BOARD ACTION REPORT – APPEALABLE ITEM

Project Name: Delray Place (Harvest Seasonal Grill)
Project Location: 1811 S. Federal Hwy
Request: Approval of a Amendment to Master Sign Program
Board: Site Plan Review and Appearance Board
Meeting Date: November 29, 2017

---STAFF REPORT---

Delray Place: (2017-258) Amendment to the Master Sign Program located at 1811 S. Federal Hwy. (Delray Place) for the restaurant Harvest Seasonal Grill.

SOUTH ELEVATION

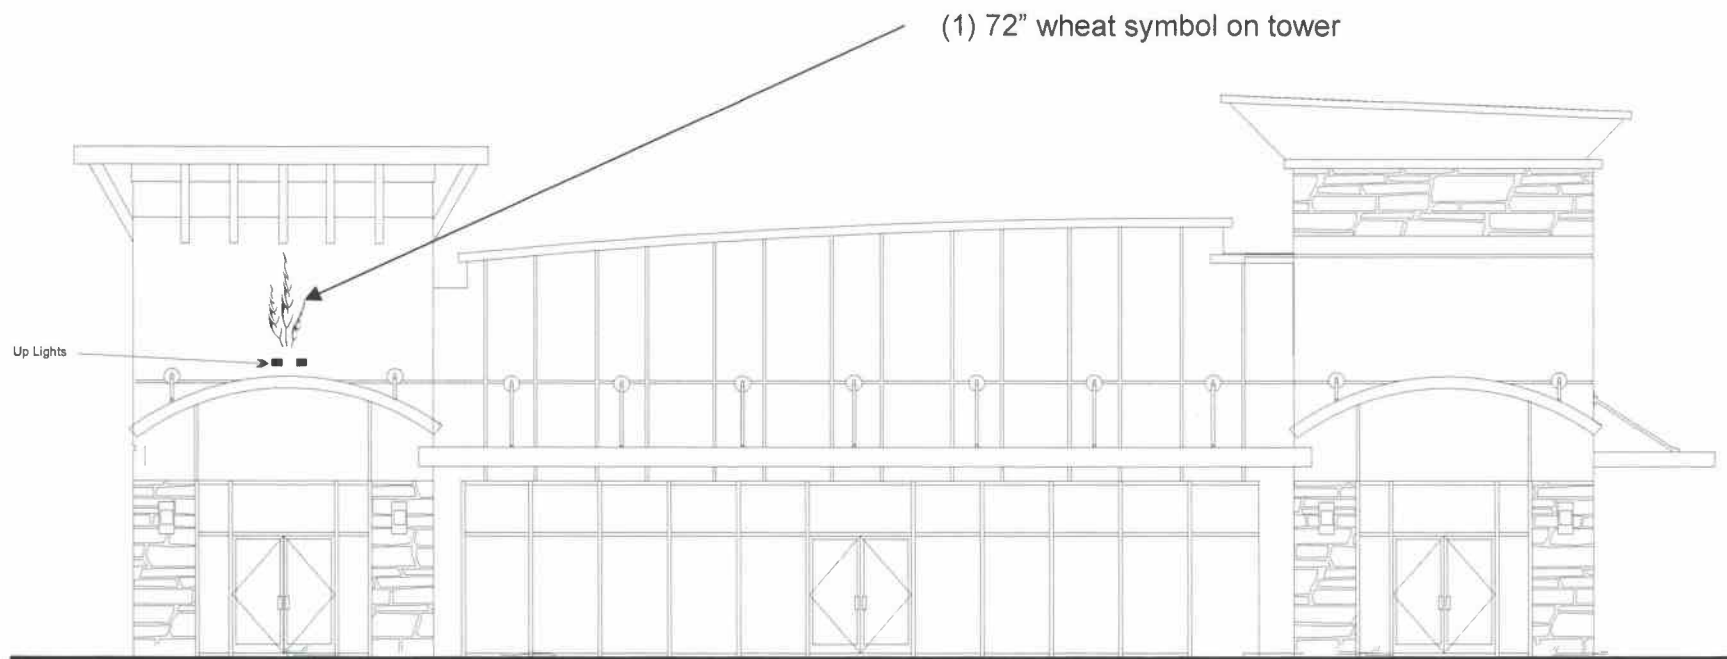
Postponed (6-0, Nancy Senelier absent) for the amendment to the Master Sign Program for Harvest Season Grill & Wine Bar (Building 400), to add the wheat logo on the south, east, and west elevations of the tower feature. The three additional wall signs proposed on the south and east elevations are 72” (6 ft.) and on the west elevation is 96” (8 ft.).

The proposed amendment does not meet the approved Master Sign Program for building 400. At the time of sign submittal in August of 2016, staff recommended that the wheat logo be incorporated into the signage as the proposed wheat logo on the tower does not meet the Master Sign Program criteria. In addition, the size of the wheat logo exceeds the allowable maximum height of a sign on this tenant space. Approval of the request would be for additional wall signs applicable to future tenants as well. It is noted that, Another Broken Egg applied for a similar request in July of 2015 to allow their logo on the tower of building 900, which only allows one wall sign. The Site Plan Review and Appearance Board denied the request unanimously. Another Broken Egg later applied to incorporate its logo with the existing wall sign; this request was approved administratively.

Move denial of the request the amendment to the Master Sign Program for additional wall signs in the tower of the east, west, and south elevations for **Harvest Season Grill**

Based on the above, staff recommends that the signage be incorporated into the existing signage that was previously approved administratively for Harvest Season Grill & Wine Bar and maintain the limits of the existing Master Sign Program.
